**From:** Sloane K. Malecki <sloane@brasshornet.com>  
**Sent:** Tuesday, April 28, 2015 5:15 PM  
**To:** paul franceschi; Jen Daugherty  
**Cc:** Erik Sellfors; CourchevelHomeowners@yahoogroups.com; Allison Amon; Sandra Moberly; Robert K. Malecki; Colin Fernie  
**Subject:** Re: Mountainside - Planning Report 4/22

**From:** paul franceschi  
**Date:** Tuesday, April 28, 2015 at 4:37 PM  
**To:** Jen Daugherty  
**Cc:** Erik Sellfors, "[CourchevelHomeowners@yahoogroups.com](mailto:CourchevelHomeowners@yahoogroups.com)", Allison Amon, Sandra Moberly, "Sloane K. Malecki"  
**Subject:** Re: Mountainside - Planning Report 4/22

**From:** paul franceschi [mailto:[franceschi.paul@gmail.com](mailto:franceschi.paul@gmail.com)]  
**Sent:** Wednesday, April 22, 2015 4:46 PM  
**To:** Jen Daugherty; Erik Sellfors; [courchevelhomeowners@yahoo.com](mailto:courchevelhomeowners@yahoo.com); [CourchevelHomeowners@yahoogleroups.com](mailto:CourchevelHomeowners@yahoogleroups.com);  
Allison Amon  
**Subject:** Mountainside - Planning Report 4/22

MOUNTAINSIDE TOWNHOMES  
 BUILDING A  
 413 RAINBOW LANE  
 MAMMOTH LAKES, CA 93546

FIGURE 1808A.7.1  
FOUNDATION CLEARANCES FROM SLOPES

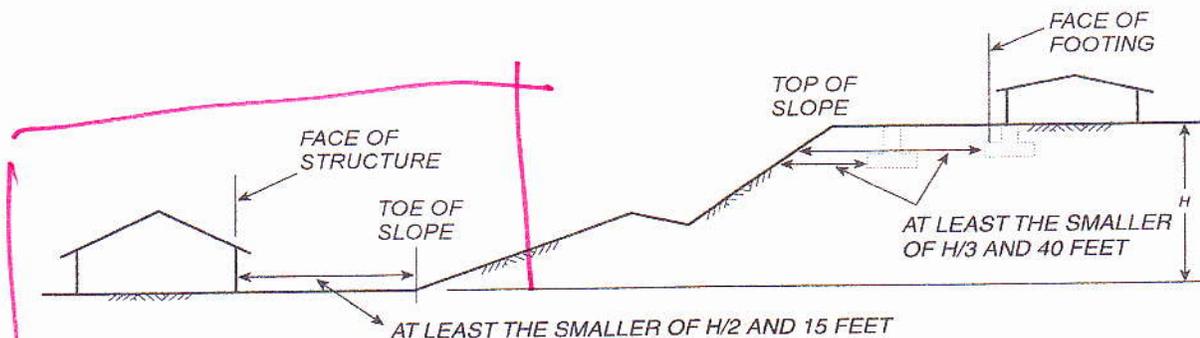
It would also seem to me that preservation of the slope is not correct. There will need to be a level yard setback between building and ascending slope per CBC1808.7 and Figure 1808.7.1 (attached).

The sections provided in the developer plans incorrectly show the slope diving directly into the back of the building without the level yard and does not show the level yard at all.
